**MONTGOMERY COUNTY HISTORIC PRESERVATION COMMISSION**  
**STAFF REPORT**

<b>Address:</b>	4823 Dorset Ave., Chevy Chase	<b>Meeting Date:</b>	12/5/2018
<b>Resource:</b>	<b>Contributing Resource</b> (Somerset Historic District)	<b>Report Date:</b>	11/28/2018
<b>Applicant:</b>	John Stewart and Sharon Stoliaroff <b>(Adam Greene, Agent)</b>	<b>Public Notice:</b>	11/21/2018
<b>Review:</b>	HAWP	<b>Tax Credit:</b>	No
		<b>Staff:</b>	Dan Bruechert

**Case Number:** 35/36-18L

**PROPOSAL:** Accessory structure and hardscape alterations

*Figure 1: The 30" mulberry tree in the rear corner of the lot splits at the trunk. It is not visible from the public right-of-way.*

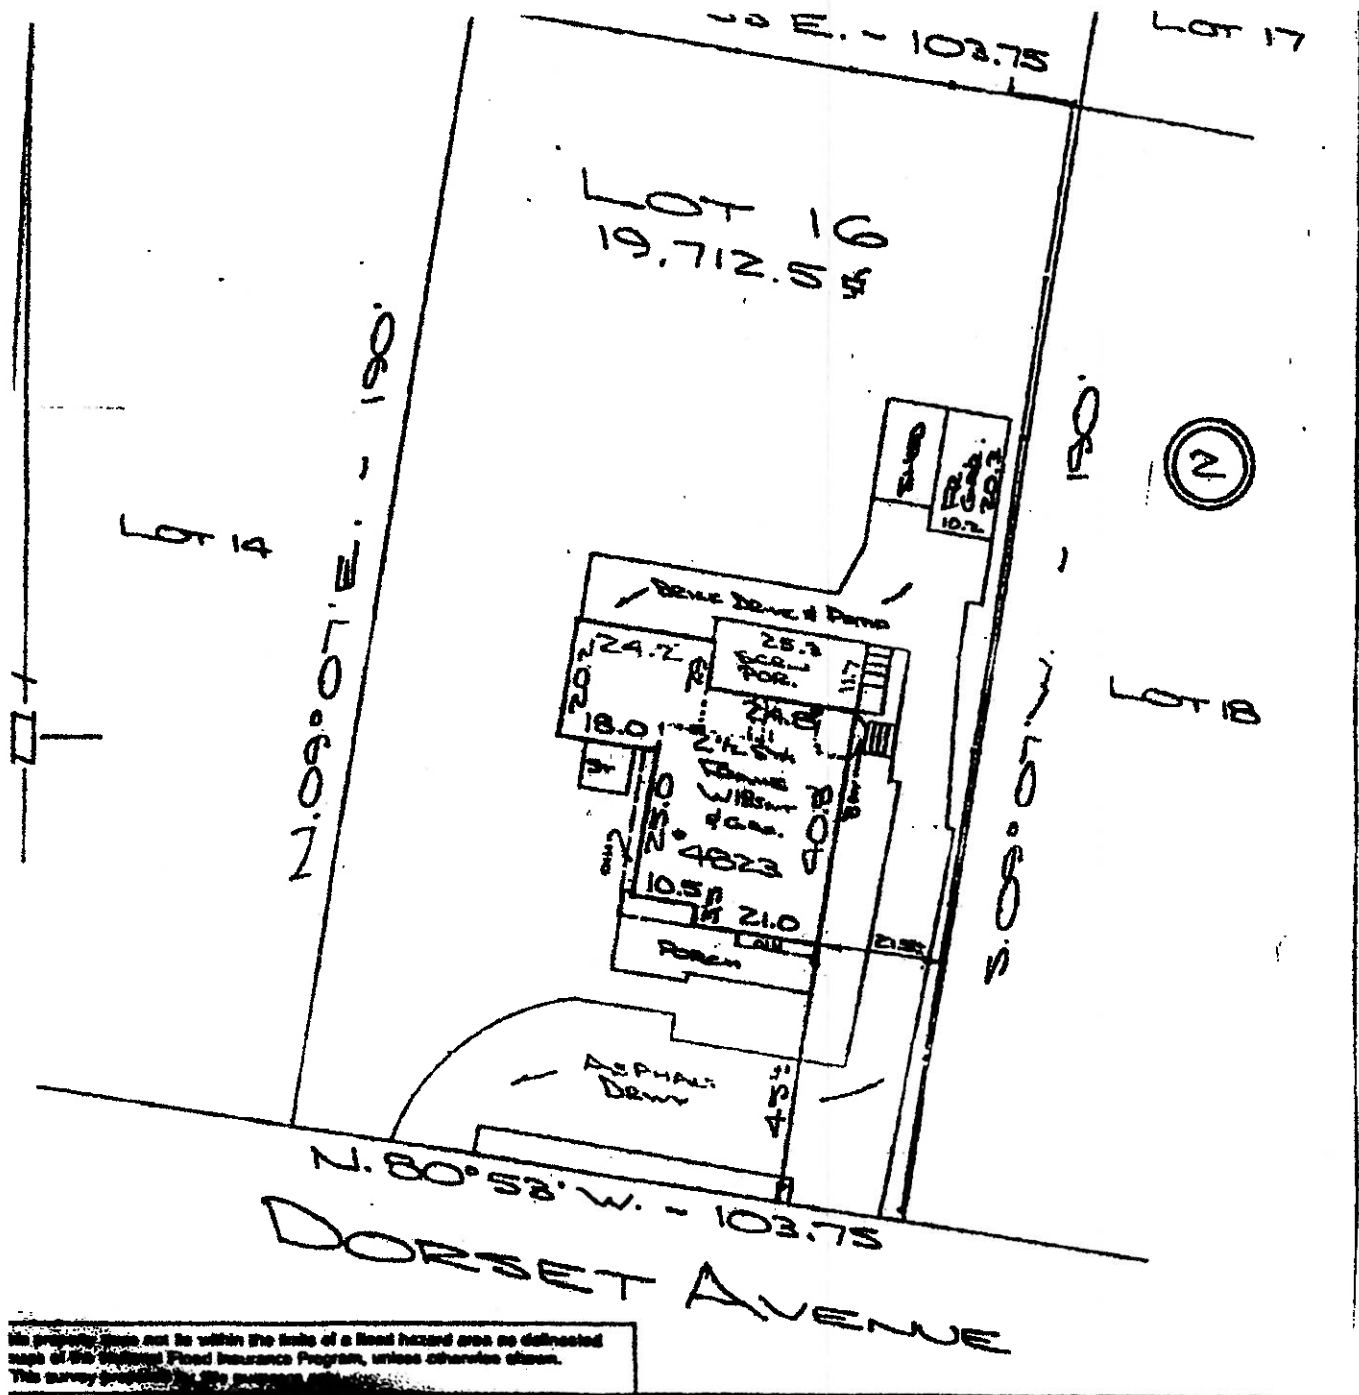
At the northeast corner of the property, the applicant proposes to remove a 30" (thirty inch) d.b.h. mulberry tree. While this tree is significant in size, it is set so far back from the street front that its removal will not impact the character of the site or surrounding district. In order to promote the mature tree canopy found throughout the district Staff recommends the HPC add a condition for approval that this tree may be removed provided the applicant plants an additional tree on the property.

1. In order to promote the mature tree canopy found throughout the Somerset Historic District, one tree must be planted on the property.
